SUBJECT: INSTALLATION OF ISOLATOR BUSHINGS FOR GARMIN GSU 25C ADAHRS
USED WITH GARMIN G3X DISPLAY

SERVICE ALERT

SK-SA001

Rev NC

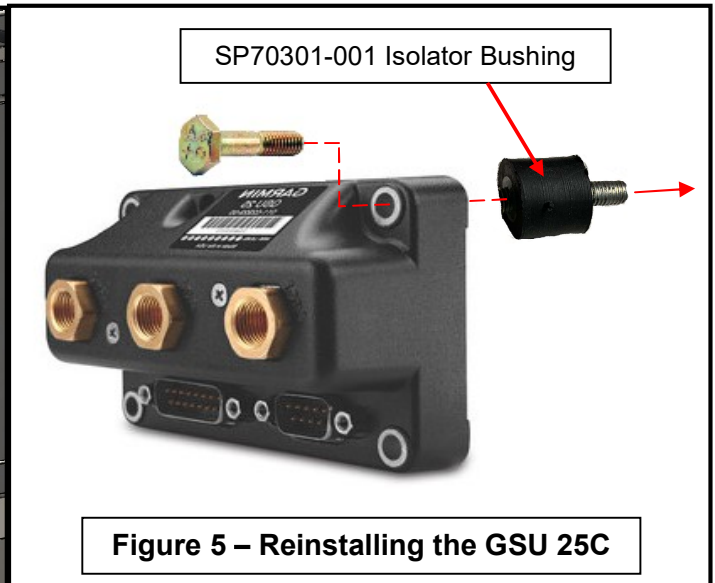
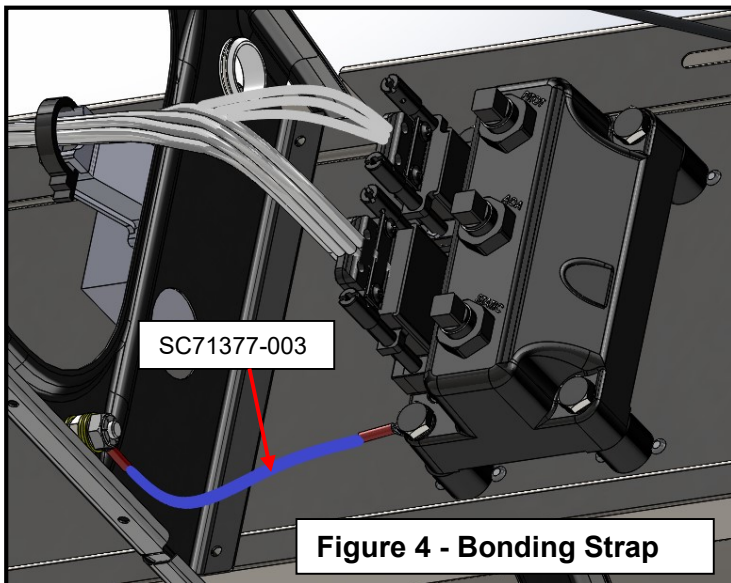
4. Reinstall the GSU 25C using four AN3 bolts (three AN3-6A bolts and one AN3-7A in the bottom, outboard corner) and the four SP70301-001 Isolator Bushings. Refer to Figure 5 and Figure 6 for details.
 - a. For the lower, outboard bolt, place one end of the bonding strap, SC71377-001, onto the bolt before inserting through the GSU and into the isolator bushing. See Figure 4.

5. Attach the free end of the bonding strap, SC71377-003, to the adjacent spar using the hardware stack-up detailed in Section R-R of Figure 6. See also Figure 4.

Figure 6 - Cross Section of GSU Mounting

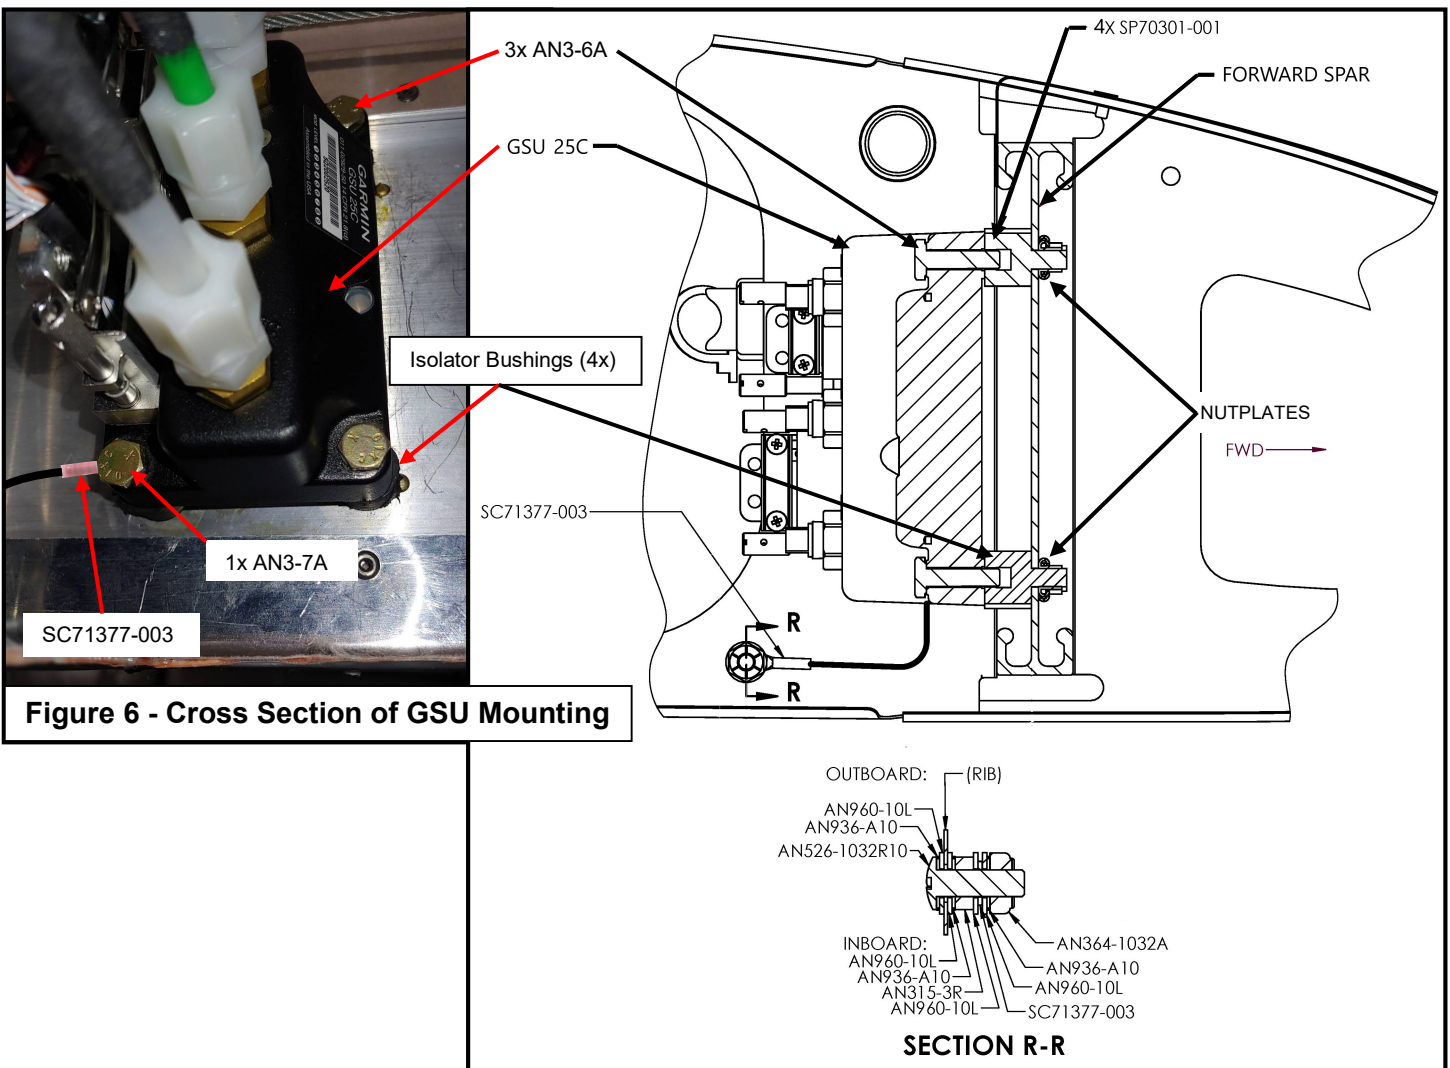
- b. Hand-tighten the isolator bushings through the spar into the nutplates. Ensure that they are fully inserted such that the rubber contacts the spar (If there were previously washers between the GSU and the spar, do not include them).
- c. Apply blue Loctite on the bolts before inserting them through the GSU 25C and into the isolator bushings (see Figure 6).
- d. Tighten all four bolts to no more than 15 inch lbs to avoid damaging the isolator bushings. If the bushing starts twisting against the GSU, stop tightening.
